ABINGTON TOWNSHIP

BOARD OF COMMISSIONERS WORKING SESSION

b. Motion to approve the Preliminary/Final Land Development - LD-22-06 - 2620 West Moreland Road (Raising Cane's).

SHEET NUMBER:
C11.0
24 OF 26

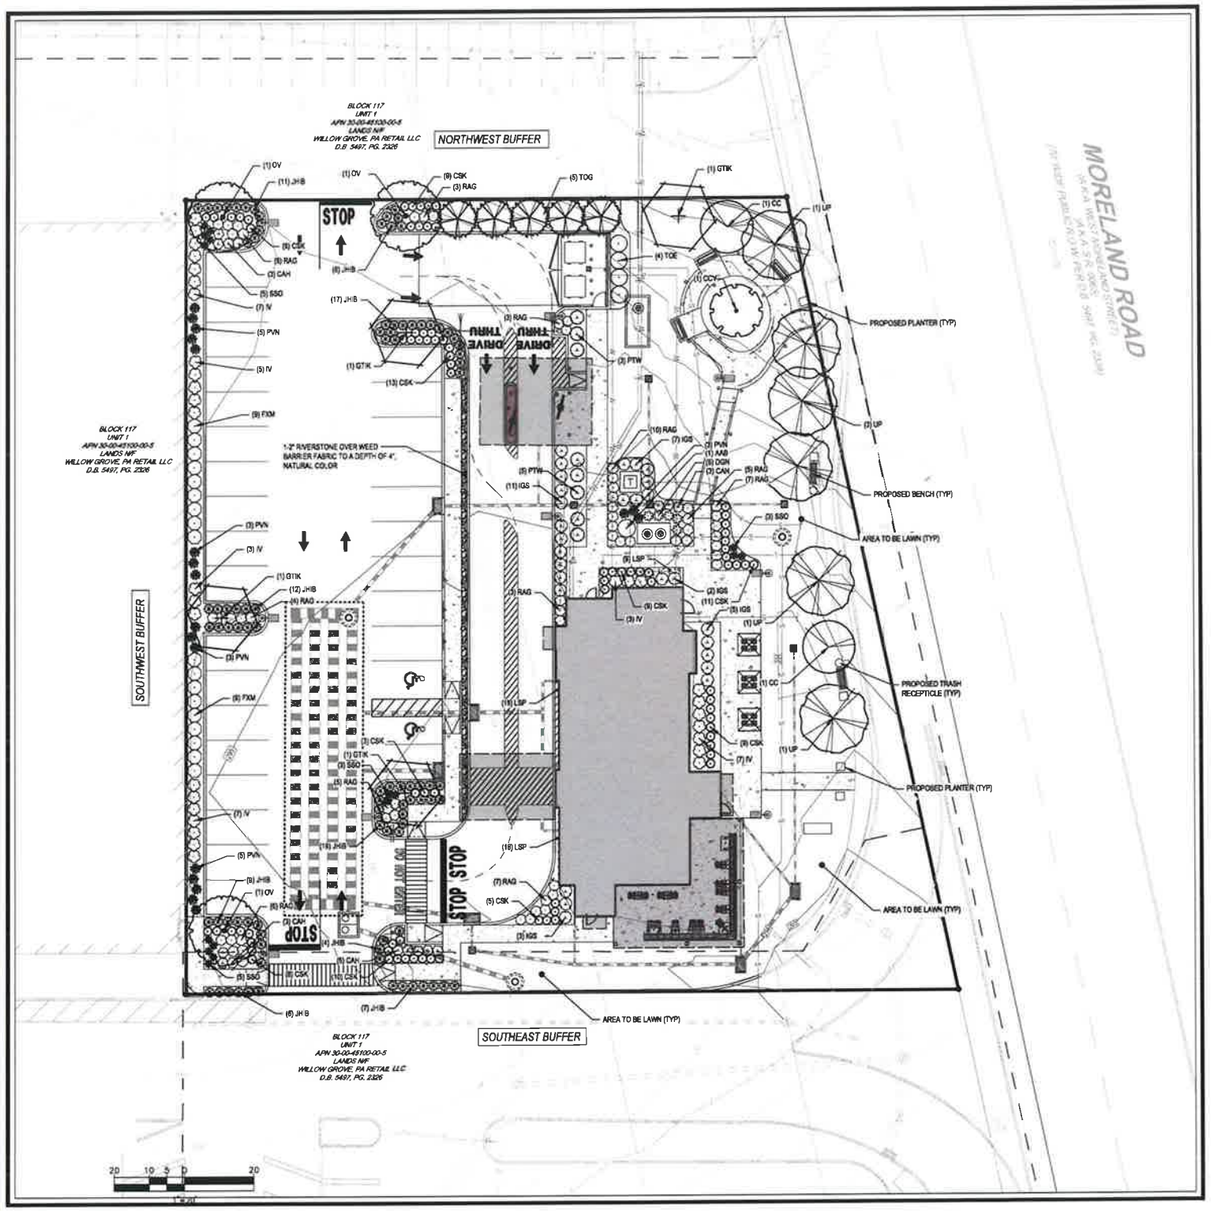
9. With respect to the landscaping specifications (Sheet 20), Notes G and H appear out of date and do not reflect current practice. Specifically, with respect to Note G: Trees can be planted year-round; in the fall, they need to be planted after dormancy, so they should be dug late in the fall. With respect to Note H: Trees should be backfilled with native material. If the native material is unsuitable, the backfill should consist of a mixture of 80% topsoil and 20% compost.

Response: The six proposed ornamental street trees have been replaced with shade trees as required (Sheet C11.0).

Response: Shrub and ornamental grasses have been provided, as requested (sheet C11.0).

Response: The CCA have been replaced with Ostrya virginiana as requested. A portion of the CC have been replaced with Ulmus americana 'Princeton' as requested (sheet C11.0)

Response: Notes G and H have been revised slightly (sheet C11.0).

Response: Acknowledged. All Slender deutzia have been replaced with Rhus aromatica 'Gro Low', as suggested (sheet C11.0).

Response: Acknowledged. All Blue Boy hollies have been replaced with Ilex glabra ‘Shamrock’ (sheet C11.0).

Response: Acknowledged. All Leatherlead Viburnums have been replaced with “Tiny Wine” Ninebark, as suggested. Please see Sheet C11-0.

2 A4.10 FRONT ENTRY ELEVATION
SCALE: 1/4" = 1'-0"

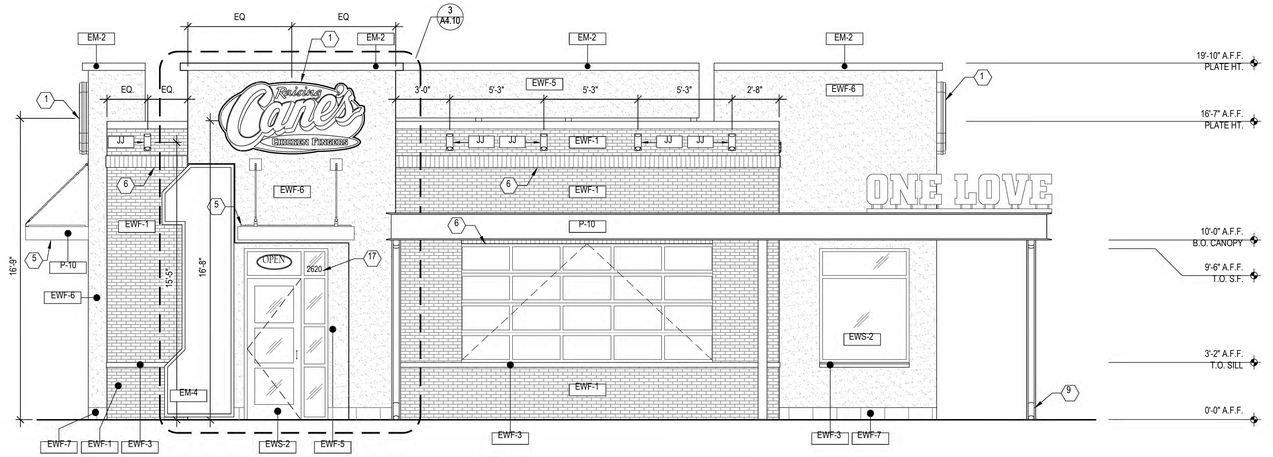
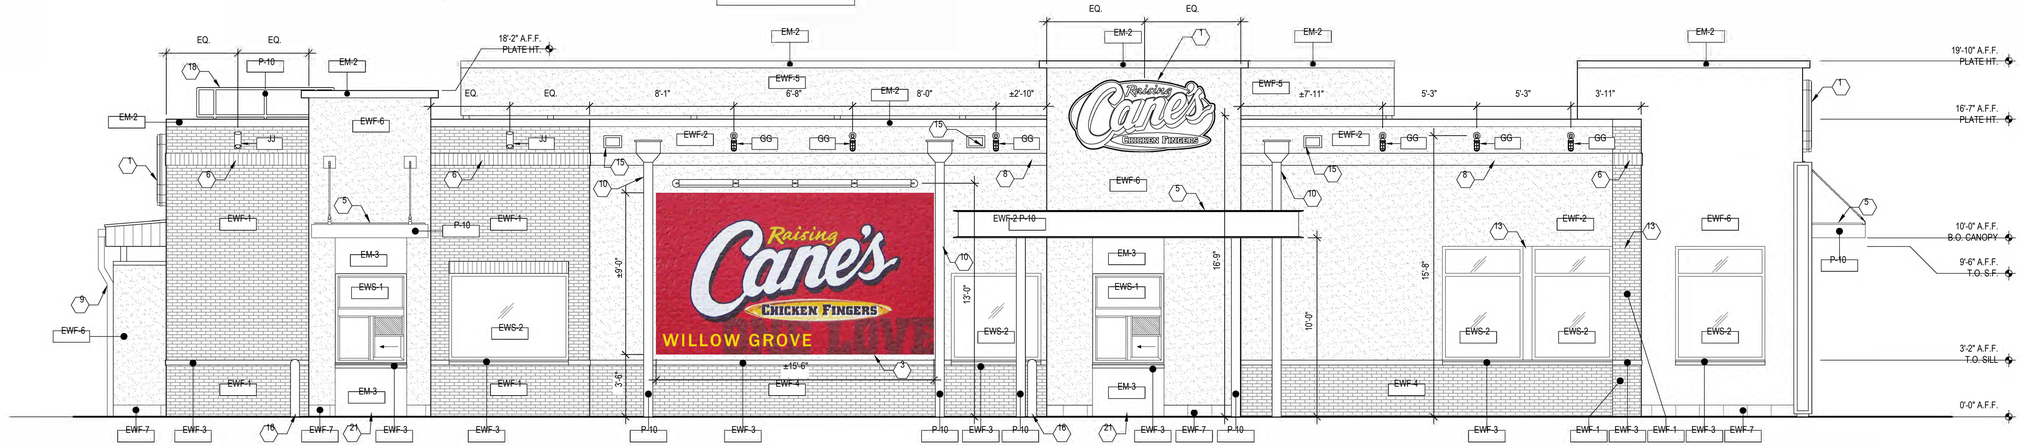
The Applicant shall confirm that the HVAC and mechanical equipment is screened from public view as indicated in this Code Section.
The Applicant has confirmed that the rooftop HVAC and mechanical equipment is screened from public view as provided on sheet A4.10. The Applicant shall submit revised architectural plans for review.

Response: Confirmed. The rooftop HVAC and mechanical equipment is screened from public view as shown on sheet A4.10
